REVISED 7-31-19: PART OF ADDENDUM NO. 1
REVISED 7-25-19: EXISTING DRAINAGE PIPE ADDED
REVISED 7-24-19: ADDITIONAL TOPO AND GRADING
LINES ADDED -PART OF ADDENDUM NO. 1

GRADING and DRAINAGE PLAN
1701 DISCIPLE DRIVE
JONESBORO, ARKANSAS
FOR
JOURNEY CHURCH

SOIL & EROSION CONTROL PLAN
1701 DISCIPLE DRIVE
JONESBORO, ARKANSAS
FOR
JOURNEY CHURCH

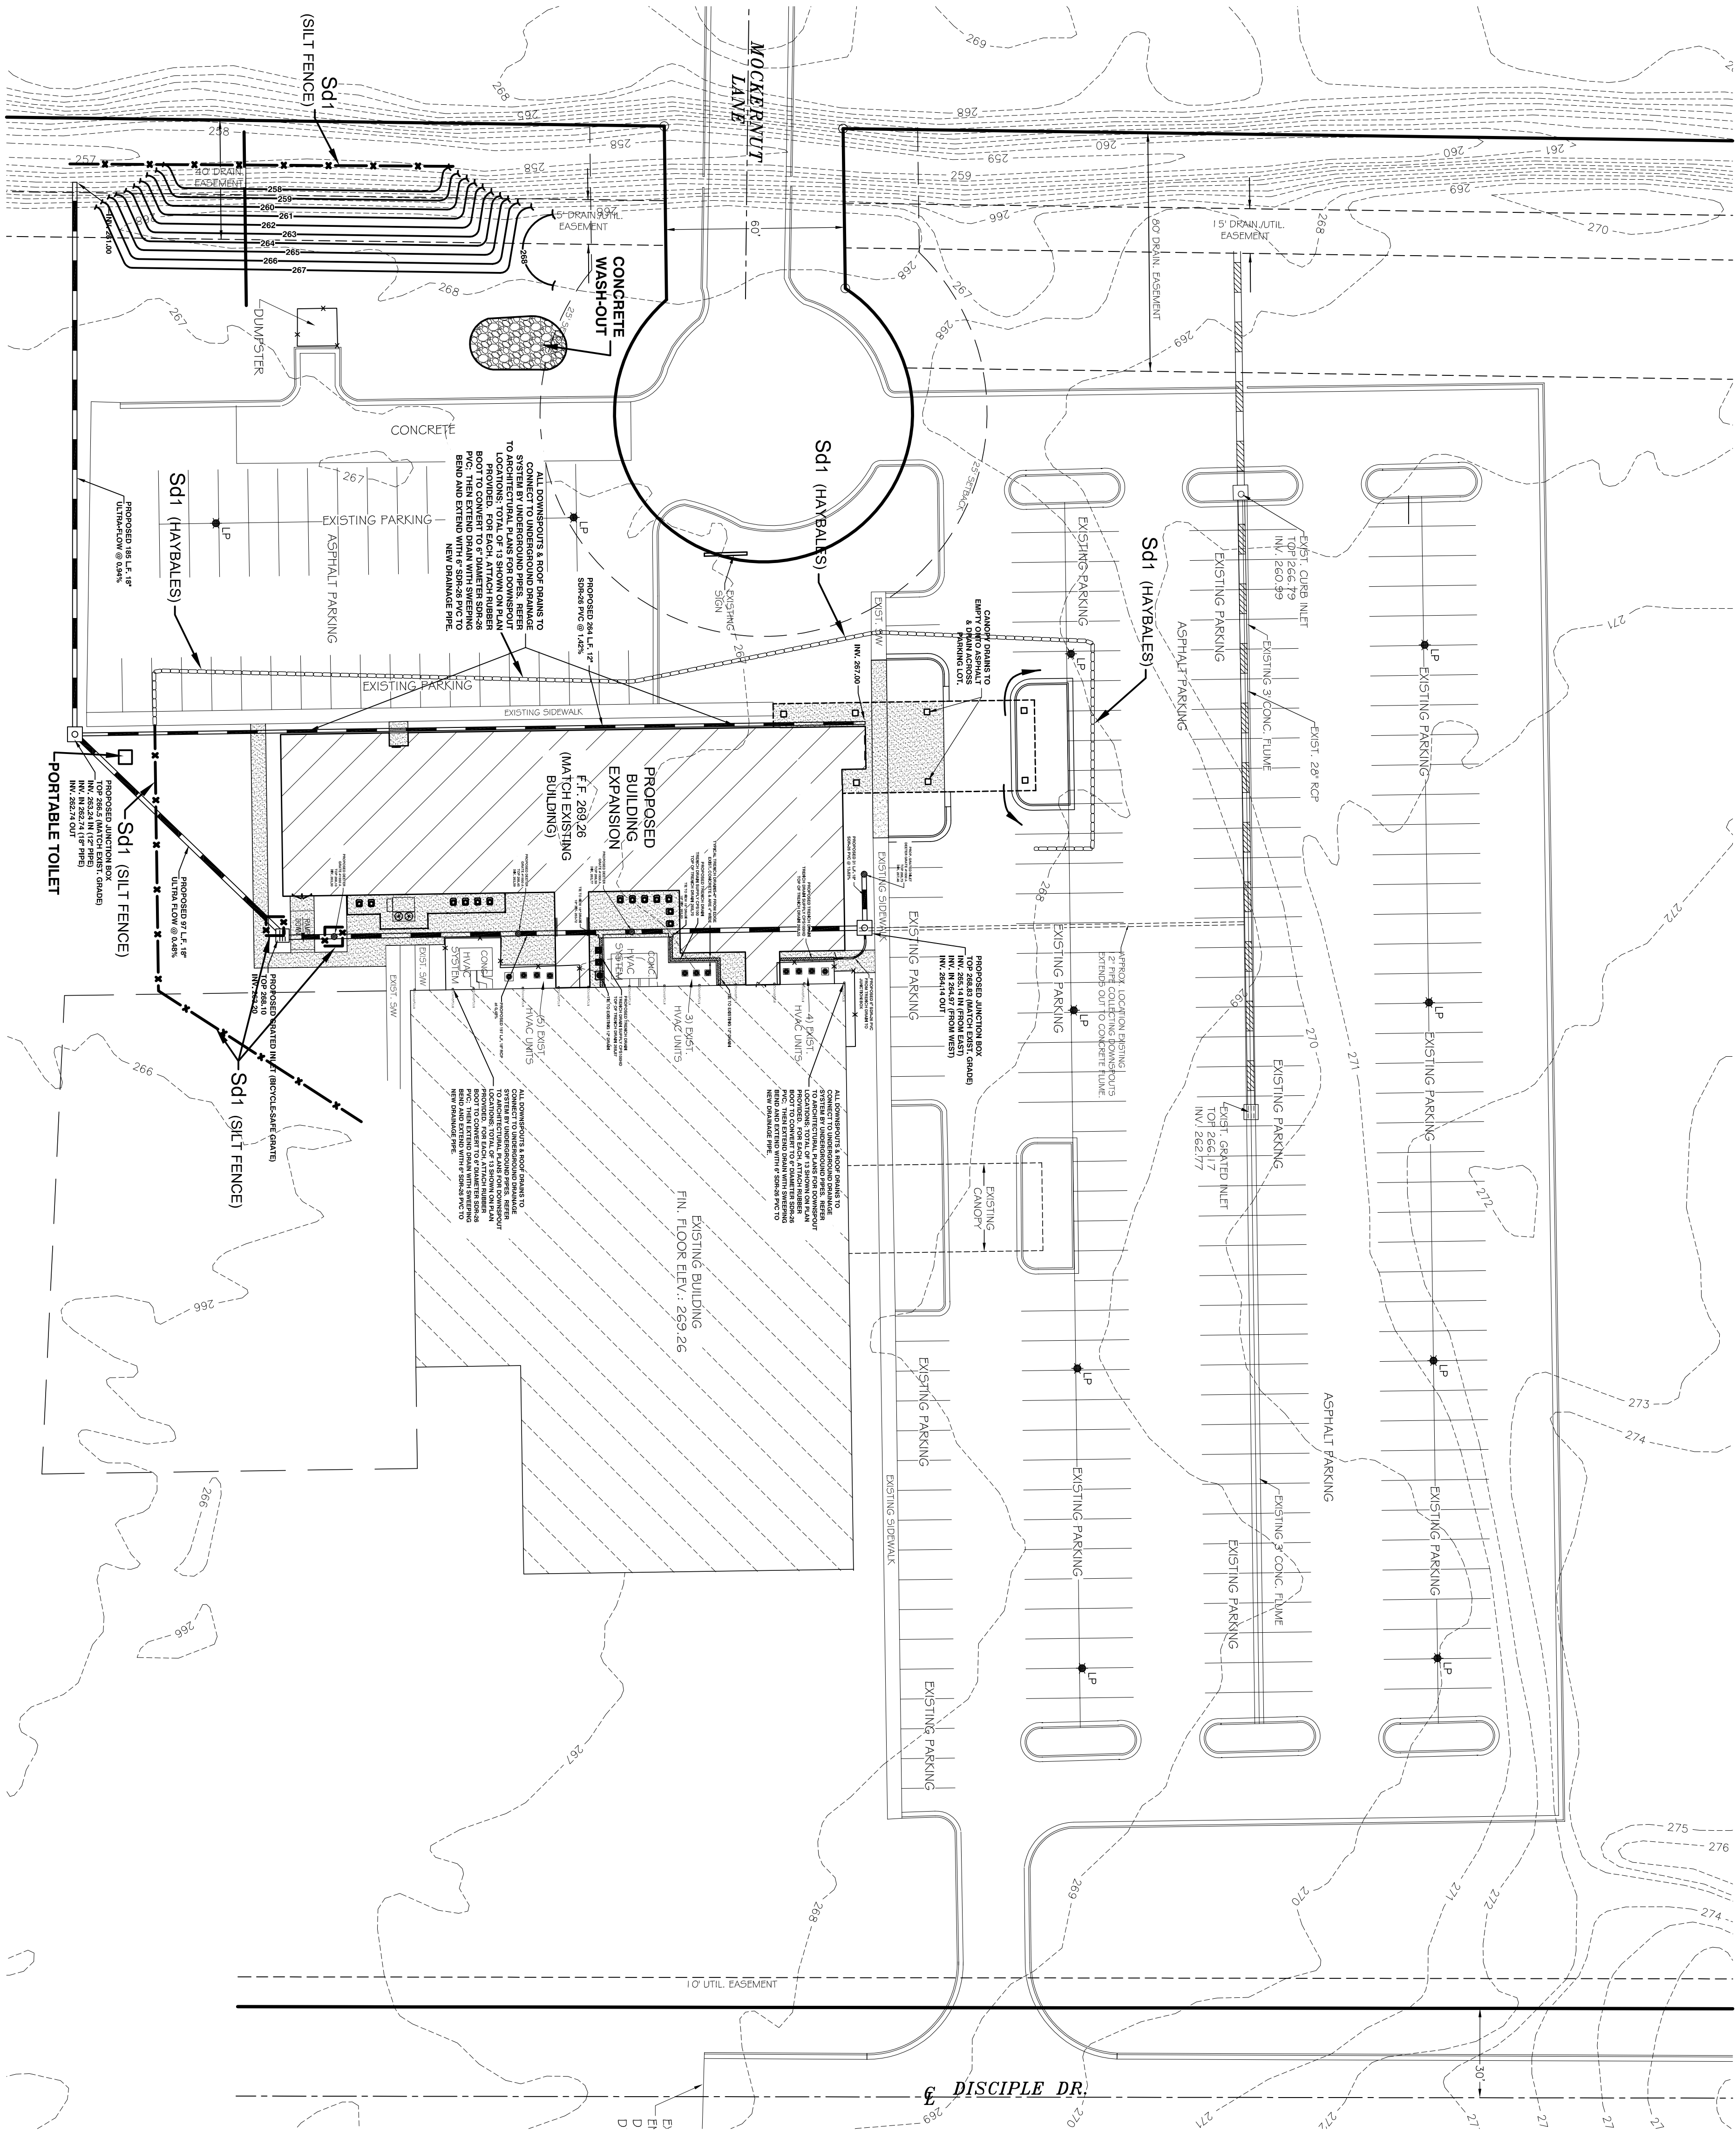
REVISED 8-05-19: PART OF ADDENDUM NO. 2
SILT FENCE ADDED
REVISED 7-31-19: PART OF ADDENDUM NO. 1
REVISED 7-24-19: ADDITIONAL TOPO AND GRADING
LINES ADDED -PART OF ADDENDUM NO. 1
